Access Compliance Report

Public Rights-of-Way

Intersection ID: 46725	Main Street: FAWN_VIEW_DR	Cross Street: HAMILTON_FOREST_DR	Location: SE
ADA ID: F0F8C696DC08	Ramp Type: Perp	Initial Pass/Fail: Fail	Overall Compliance: No
		Severity Score: 12.5

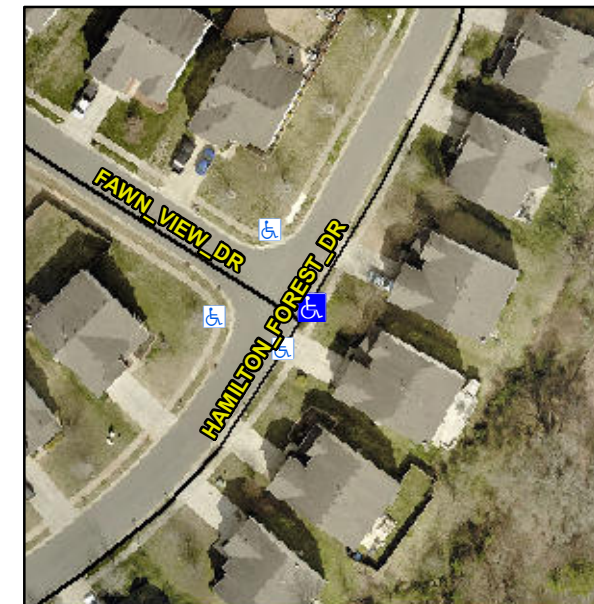
Not Found, R304.2.2

Compliance	Description	Data	Compliance	Description	Data
N/A	Ramp Length (in)	46.5	No	Ramp Slope (%)	9.1
Yes	Ramp Width (in)	48.0	Yes	Ramp XSlope (%)	1.9
N/A	Flare Type LT	N/A	N/A	Flare Type RT	N/A
N/A	Flare Slope LT (%)	N/A	N/A	Flare Slope RT (%)	N/A
N/A	Flare Traversable LT?	N/A	N/A	Flare Traversable RT?	N/A
N/A	Landing Length (in)	N/A	N/A	DWS Provided?	N/A
N/A	Landing Width (in)	N/A	N/A	DWS Contrast?	N/A
N/A	Landing Slope (%)	N/A	N/A	DWS Length (in)	N/A
N/A	Landing X Slope (%)	N/A	N/A	DWS Full Width?	N/A
N/A	Landing Curb? (Y/N)	N/A	N/A	DWS Offset (in)	N/A
N/A	Shared Landing?	N/A			
N/A	Gutter Ponding?	N/A	N/A	Gutter Slope (%)	N/A
N/A	Gutter Lip Ht (in)	N/A	N/A	Gutter X Slope (%)	N/A
N/A	Painted X Walk1?	No	N/A	Painted X Walk2?	N/A
	X Walk 1 Direction	To NE		X Walk 2 Direction	N/A
N/A	X Walk 1 Width (in)	N/A	N/A	X Walk 2 Width (in)	N/A
	X Walk 1 Slope (%)	1.4		X Walk 2 Slope (%)	N/A
	X Walk 1 X Slope (%)	3.1		X Walk 2 X Slope (%)	N/A

Remove & Replace Entire Ramp.
